HOLTEC INTERNATIONAL

June 23, 2006

Subject: Submittal of License Amendment Request #5 to HI-STORM 100 CoC

Document ID: 5014600

FIGURE 2.1-3

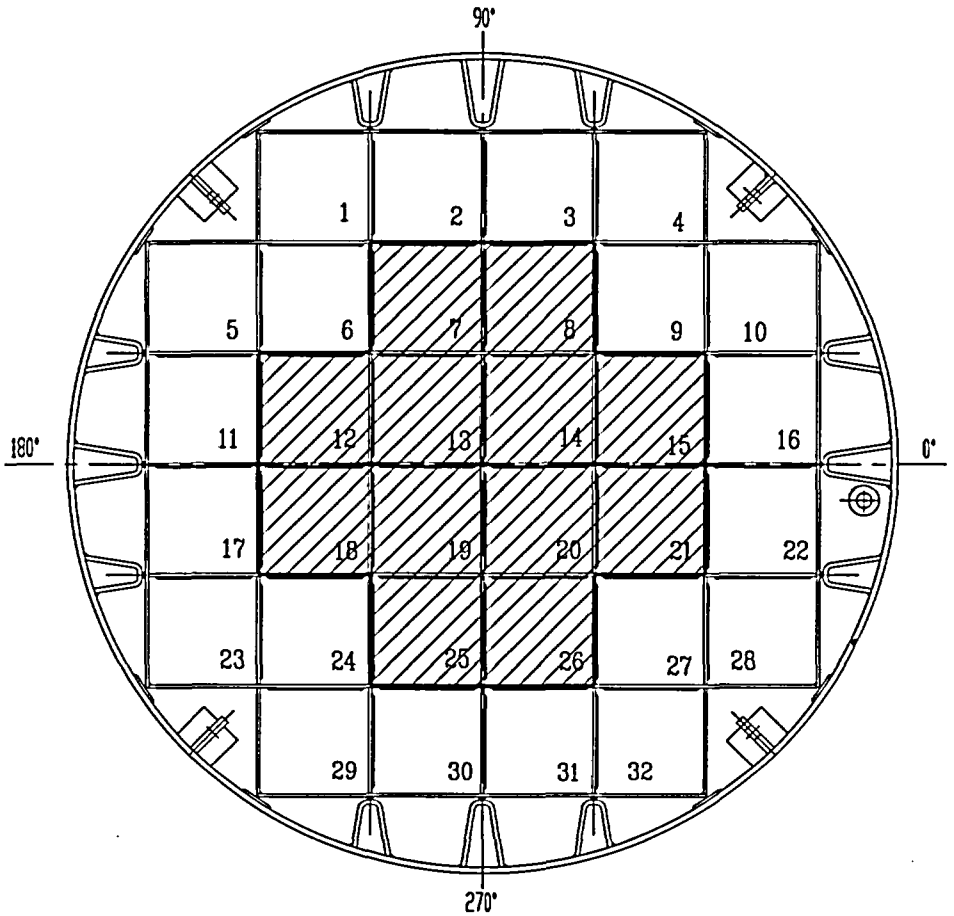
1. Separate burnup, cooling time, and decay heat limits (30,000 MWD/MTU, 30 year cooling, 250 watts/assembly) for Array/Class 14x14E were added for the MPC-32 and MPC-32F.
2. Antimony-beryllium secondary sources are permitted to be stored with Indian Point Unit 1 fuel assemblies, Array/Class 14x14E.
3. All Indian Point Unit 1 fuel assemblies are required to be stored in damaged fuel containers and 32 DFCs with Indian Point Unit 1 fuel are permitted for storage.
4. Indian Point Unit 1 fuel debris is not permitted for storage in the MPC-32 or MPC-32F.

ISOMETRIC VIEW OF HI-TRAC 100D TRANSFER CASK

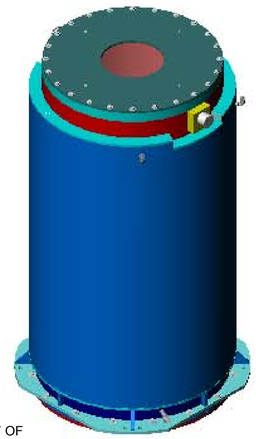
1. Notes have been added to MPC-32 drawing 3927 to differentiate the Indian Point Unit 1 (IP1) specific MPC-32 from the generic MPC-32.
2. Notes have been added to the MPC enclosure vessel drawing 3923 to differentiate the IP1 specific MPC enclosure vessel from the generic MPC enclosure vessel.
3. Notes have been added to the HI-STORM 100S Version B drawing 4116 to identify the HI-STORM 100S-185 variant for use at IP1.
4. A new licensing drawing for the HI-TRAC 100D Version IP1, drawing 4724, has been created.
